REPORT NO. B-1256

Report of
Test on Siren, Motor-Operated,
Submitted by
Federal Electric Company,
Chicago, Illinois

NAVY DEPARTMENT
BUREAU OF ENGINEERING

METHOD OF MOUNTING
ROTOR

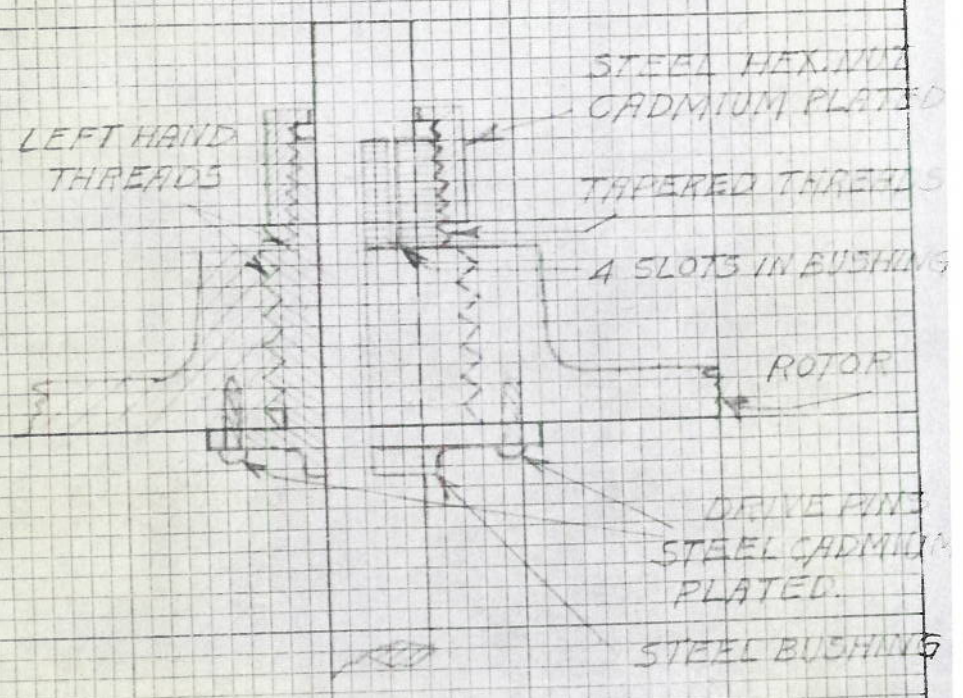
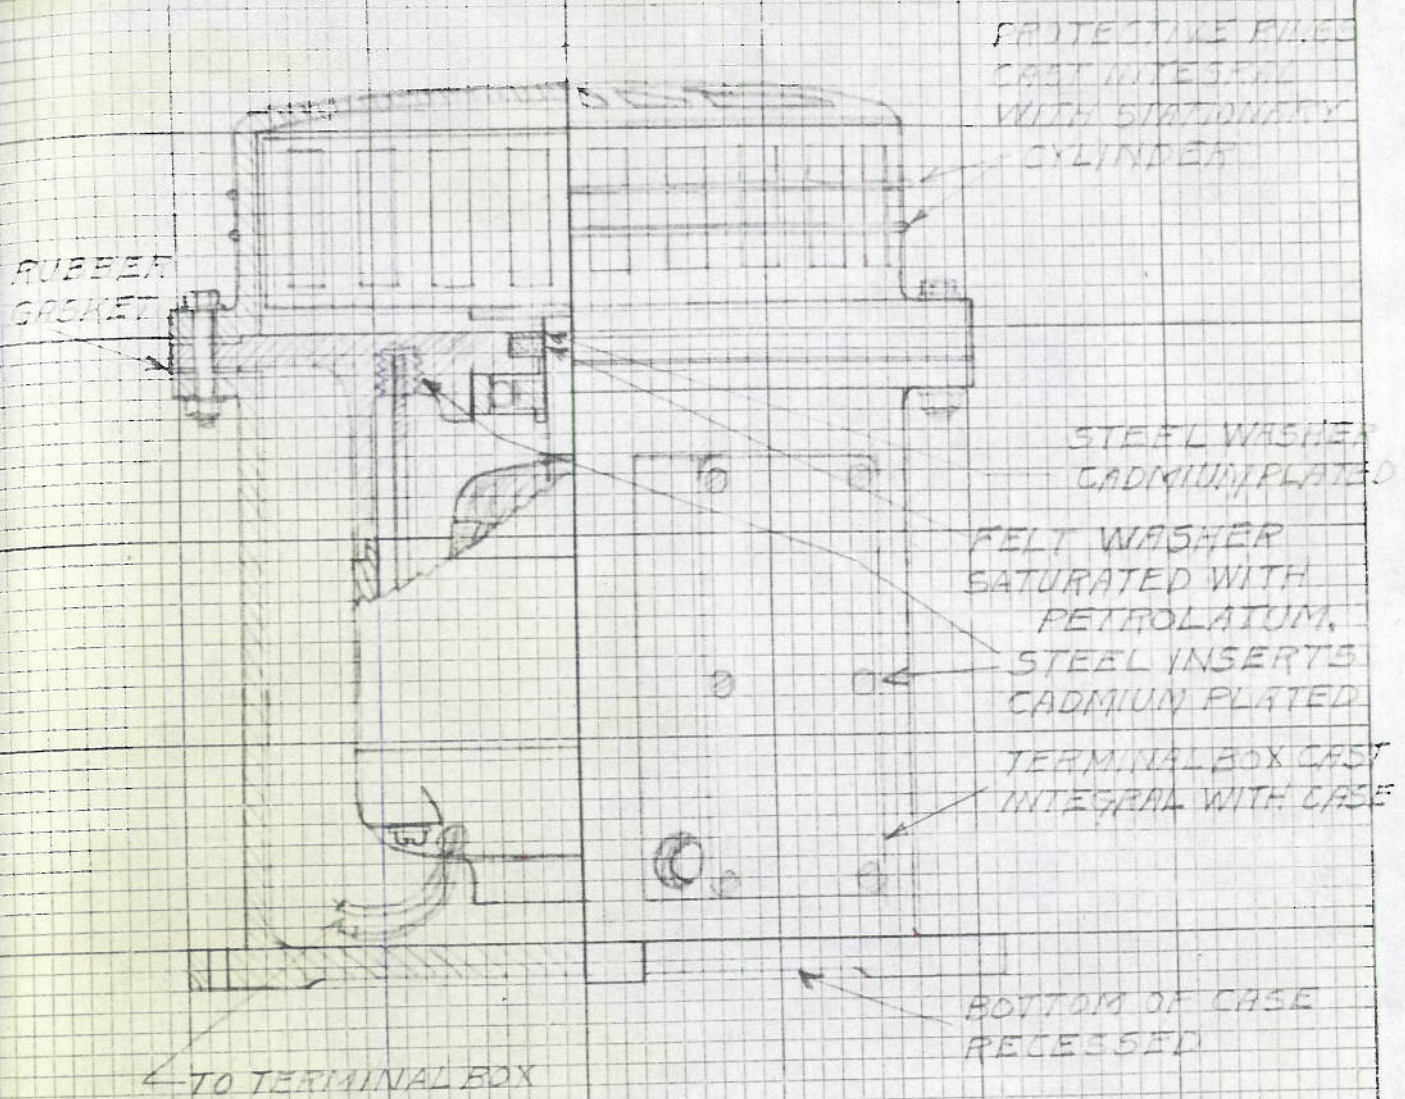
(b) Inasmuch as the workmanship on the siren is good and it meets the specifications relative to the electrical characteristics, it is also recommended that the manufacturer be invited to build a siren, incorporating features shown on Plate 3, and submit same to this Laboratory for type approval test. Plate 3, a sketch of a desirable type of construction, has not been listed in the table of contents of this report.

- (c) A better method should be employed for securing the rotor to the motor shaft, possibly by using a split steel conical bushing having external threads and provided with a suitable nut and locknut. All steel parts should be protected against corrosion.
